March 10, 2022

To: Alaa M. Abusalah
Director of Development & Inspectional
Services/Town Planner
3 Washburn Square
Leicester, Massachusetts 01524

A&M Project #: 2889-01
Re: Skyview Estates
Special Permit /
Site Plan Review
Town & Engineer Comments
651 Main Street
Map 21/Parcel B5.1

Please find Allen & Major Associates, Inc. (A&M) responses to the review memo prepared by Quinn Engineering Inc., dated March 7, 2022 which summarized the telephone conference to discuss remaining unresolved comments from the Quinn Review letters addressed to Leicester Planning Board dated 2/12/2022 and to Leicester Zoning Board of Appeals dated 3/2/2022. The comments are reproduced below along with the A&M's response and/or comments.

DRAWING TITLE: PROPOSED WATERSHED PLAN

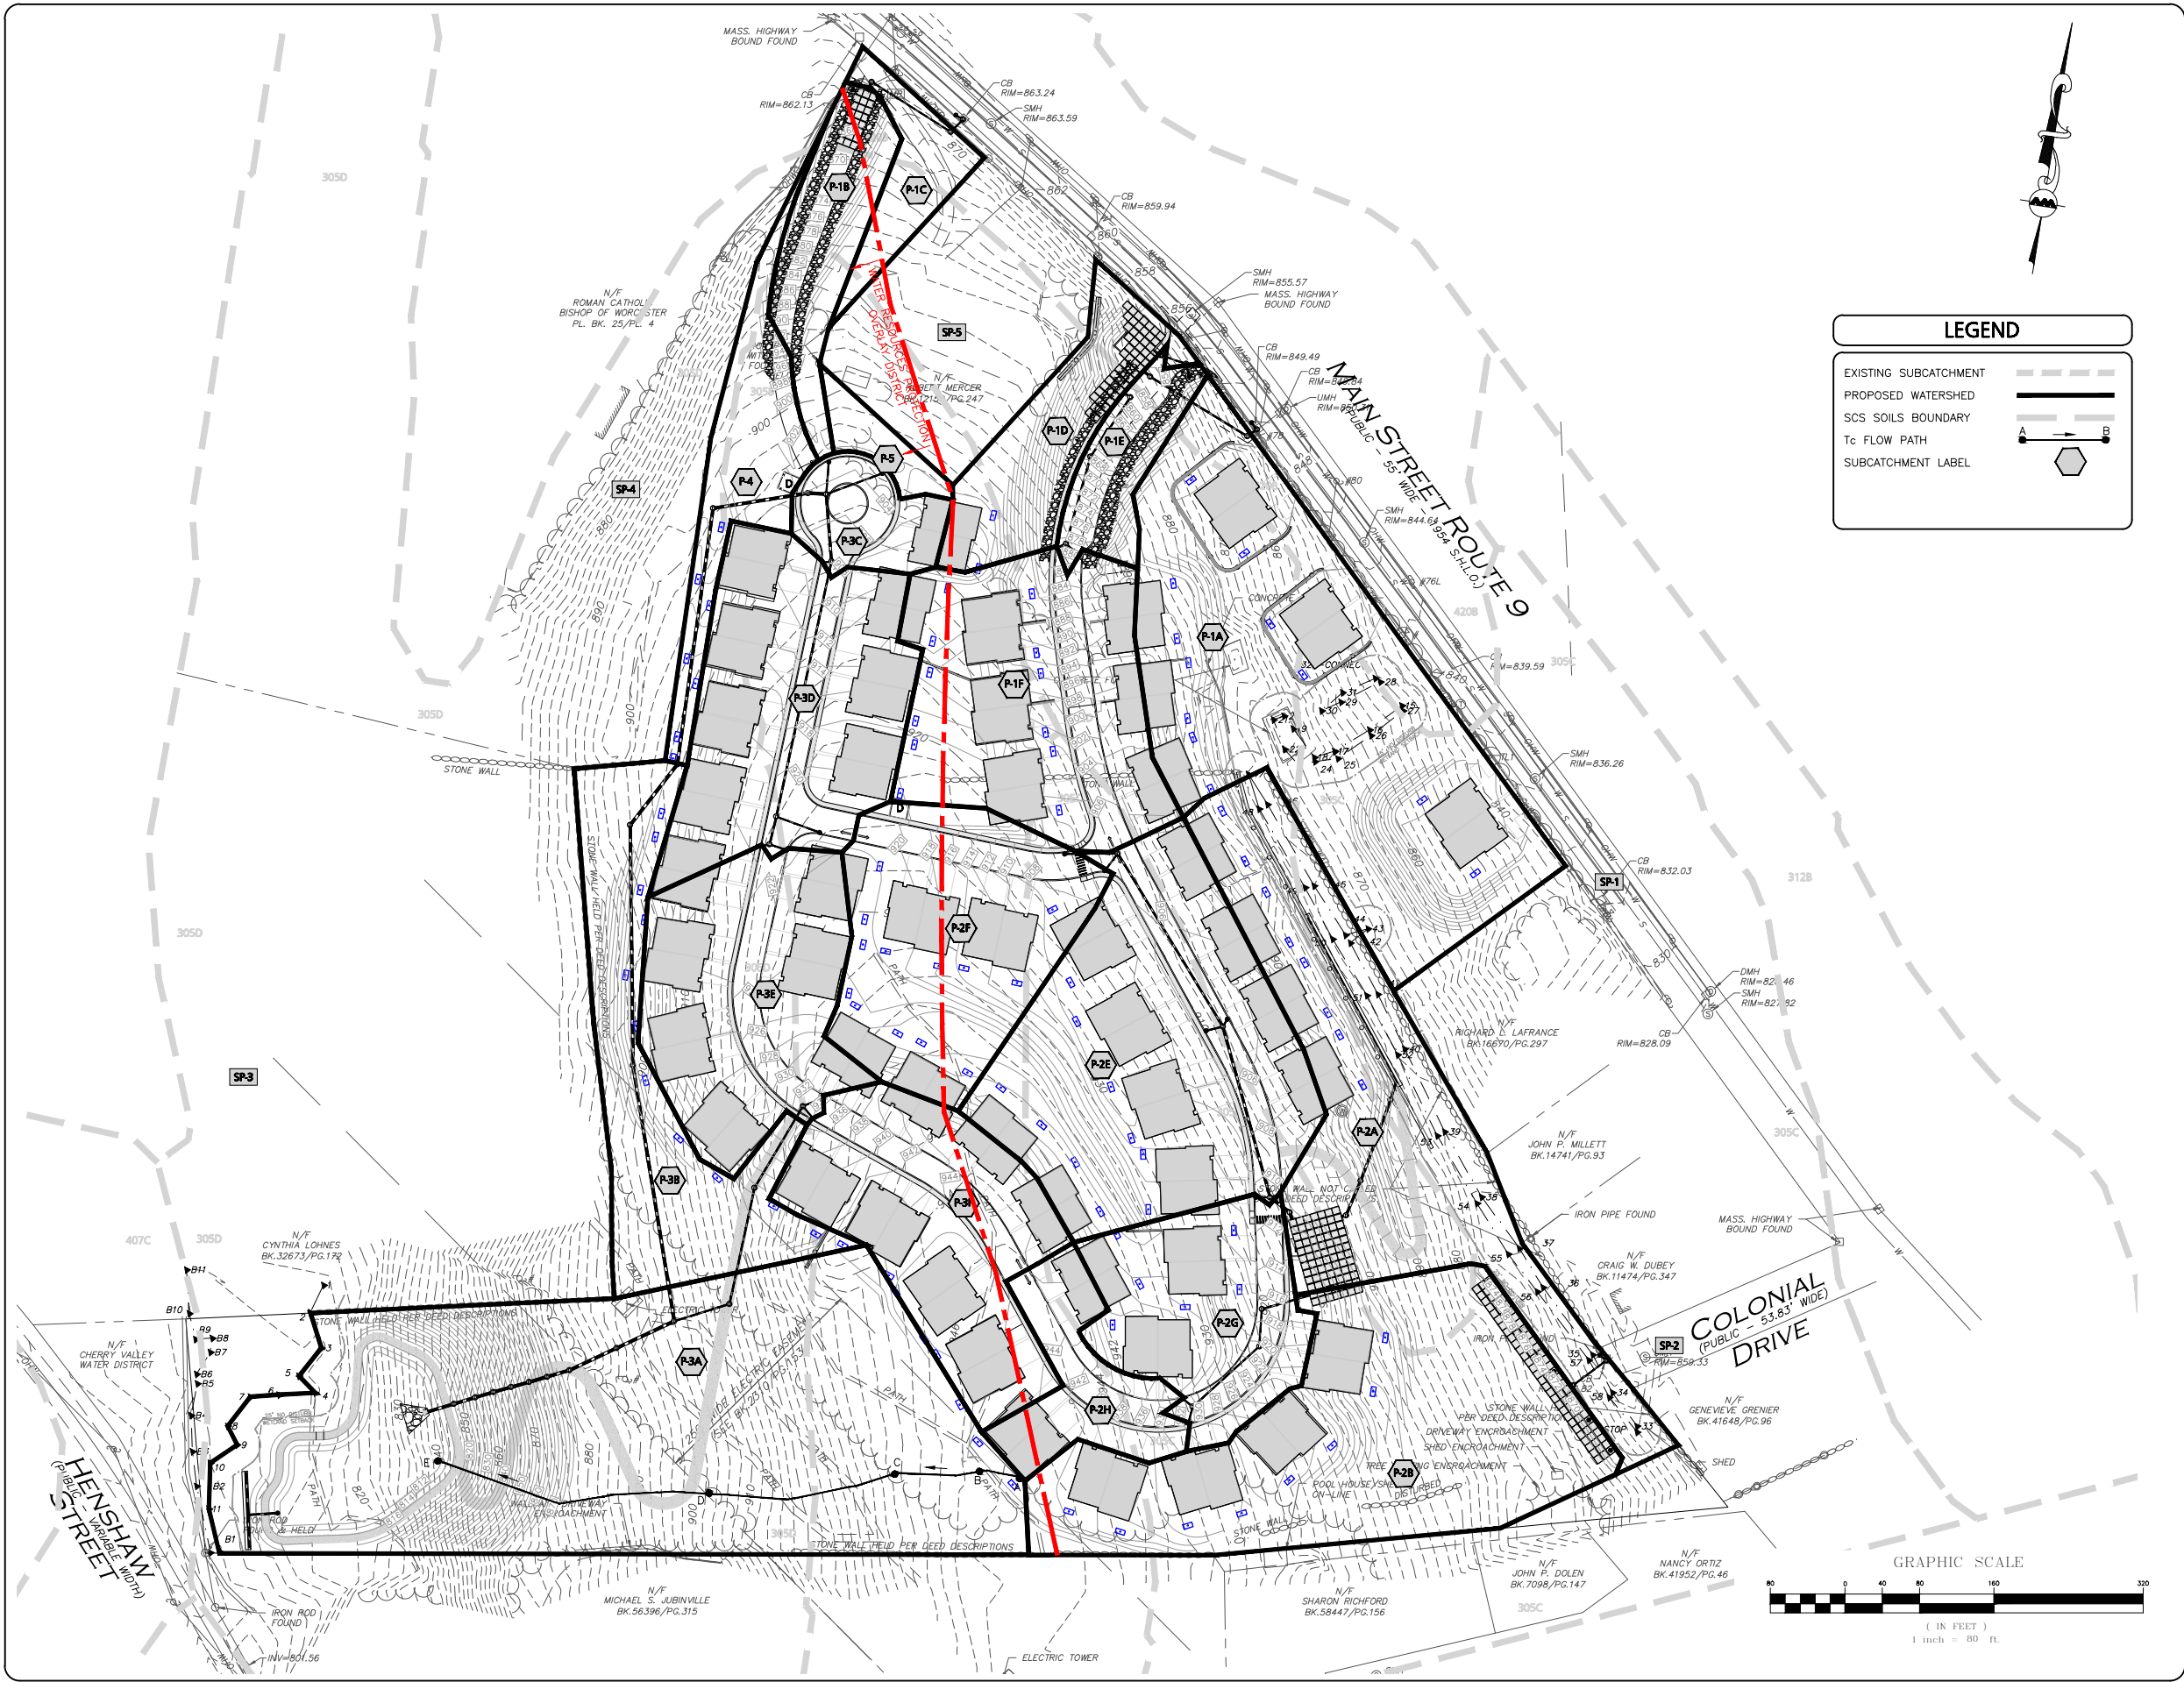
MM will address compliance with the stormwater recharge standard, as enumerated in §7.1.04, 2, a, within the area designated at Water Resources Protection Overlay District.

Response: Agreed. Refer to attached supplemental calculations which illustrate that the required infiltration is achieved within the area of the overlay district.
